HOUSING AUTHORITY OF THE CITY OF PUEBLO  
and El Centro Pueblo Development Corporation, Inc.  
201 S. Victoria Avenue, Pueblo, CO 81003

**ADDENDUM 3**

**BID NUMBER:** I.F.B. 17-524-RAD  
**PROJECT:** Infrastructure & New Construction of 72 Units  
**LOCATION:** Uplands Townhomes, Pueblo, Colorado

**AD-2**  
 I.F.B. 17-524-RAD  
 DRAWN BY:  
 TWO WAY  
 CLEANOUT  
 DATE: 5/19/17  
 PROJECT: UPLANDS  
 TOWNHOMES

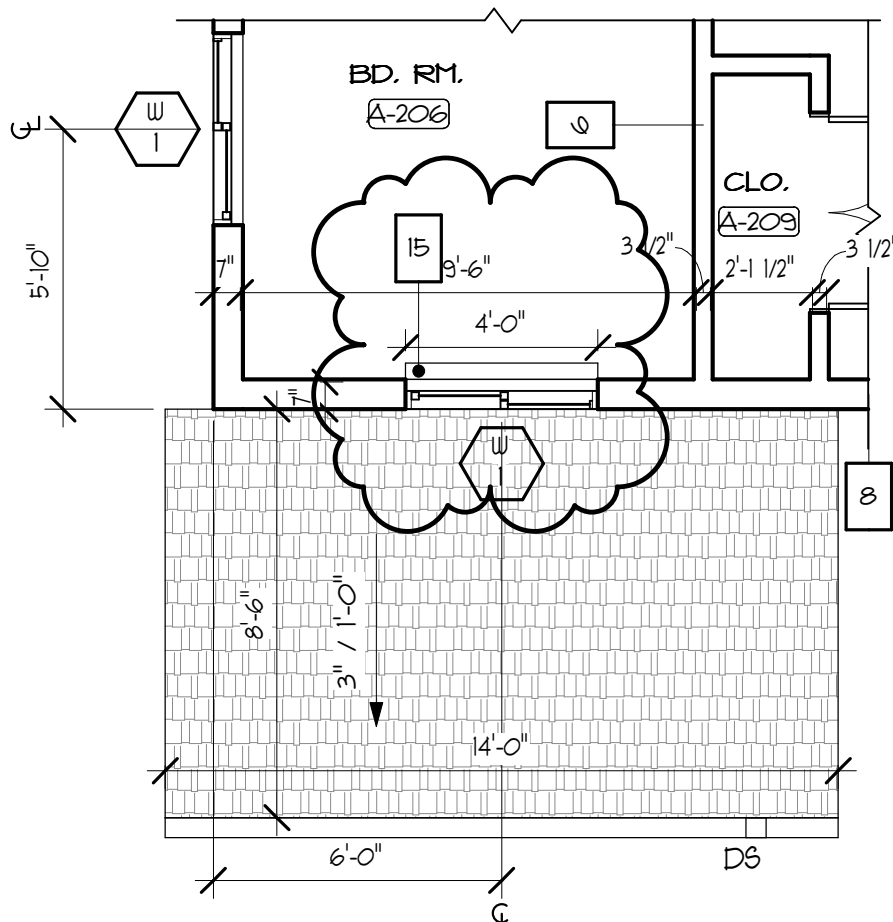
Sanitary sewer cleanouts on 4" PVC as shown on the Utility Plan shall be two-way cleanout as per Addendum drawing AD-2.

# TWO-WAY SANITARY CLEAN OUT DETAIL

### 1 PLAN DETAIL at WINDOW

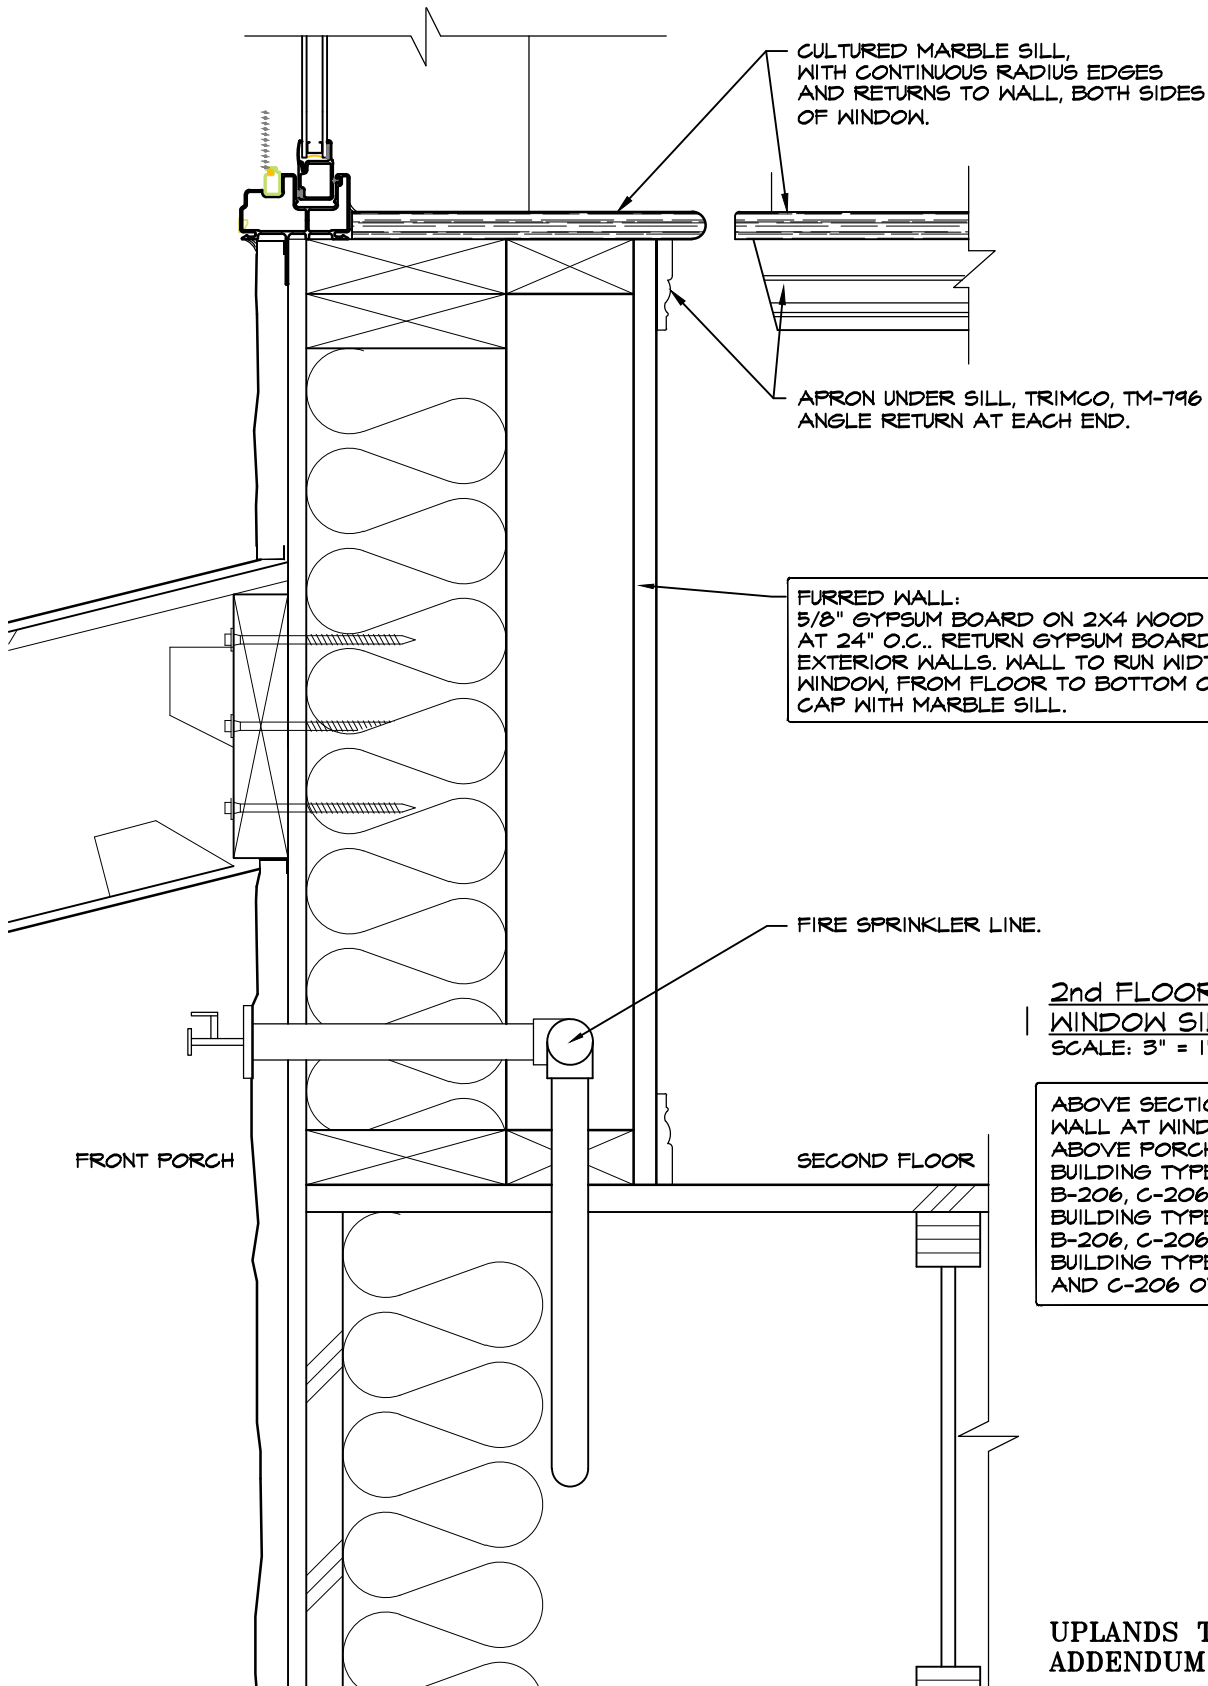
Furred wall under the windows at entry porches per Addendum drawing AD-3 and AD-4.

**Note:** This requirement is to provide a chase for a “dry” pipe for a fire protection sprinkler requirement.

NOTE: ABOVE DETAIL for FURRED WALL at WINDOW is TYP. at WINDOW TYPE No. 1 ABOVE PORCH ROOFS in BLDG. A BD. RM.s A-206, B-206, C-206, D-206; BLDG C BD. RM.s A-206, B-206, C-206, D-206, E-206; BLDG. E BD. RM.s B-206 and C-206 ONLY.

TYPE MARK	DESCRIPTION	FIRE RATING	STC RATING
15	2x4 WD. STUDS at 24" O.C. with 5/8" TYPE "X" GYP. BD. INTERIOR SIDE ONLY. WRAP GYP. at ENDS of WALL. WALL SHALL EXTEND from TOP of FLOOR to UNDERSIDE of WINDOW SILL ABOVE. CULTURED MARBLE WINDOW SILL SHALL CAP FURRED WALL.	N/A	N/A

AD-5  
I.F.B. 17-524-RAD  
DRAWN BY: JC  
BUILDING TYPE "D"  
KITCHEN ELEVATIONS  
DATE: 5/19/17  
PROJECT: UPLANDS TOWNHOMES

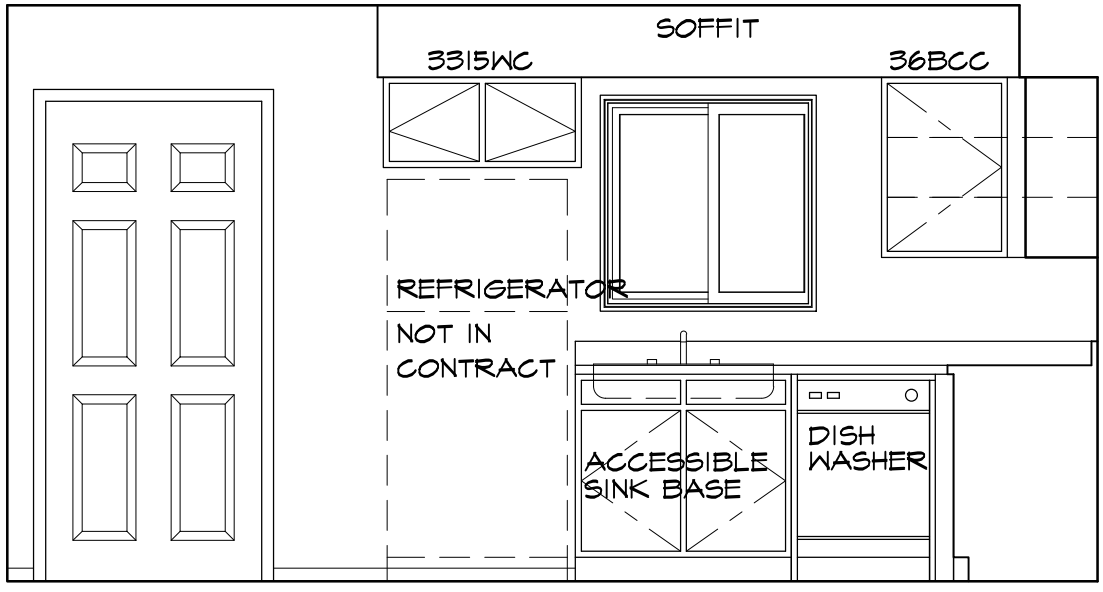
Kitchen Casework Elevations are modified per Addendum Drawing AD-5.

3 KITCHEN ELEVATION A  
SCALE 3/8" = 1'-0" (102)

17 KITCHEN ELEVATION A  
SCALE 3/8" = 1'-0" (102)
